NABCO ENTRANCES TECHNICAL BULLETIN

Revised Specifications for NAX Hermetic Doors

Bulletin Number: **95**

Double-sided flat frame

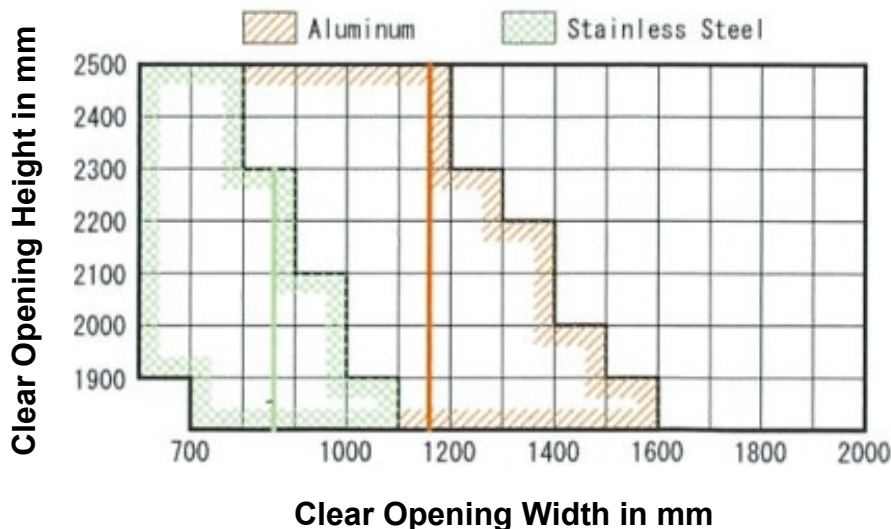
1. The optional viewing window in the GT9100 and GT9300 now only comes in a flat frame. This change is to help prevent dust accumulation and enhance ease of cleaning.

Aluminum Panel Section

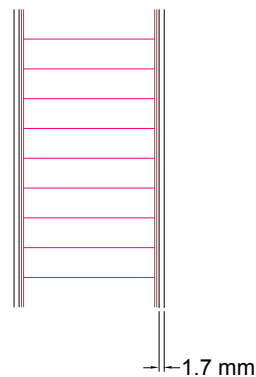
2. The skin thickness on an aluminum door has increased from 1.5mm to 1.7mm. This increased thickness affects the maximum clear vertical and horizontal opening for the aluminum version only. The difference is small but needs to be accounted for, please see the following chart:
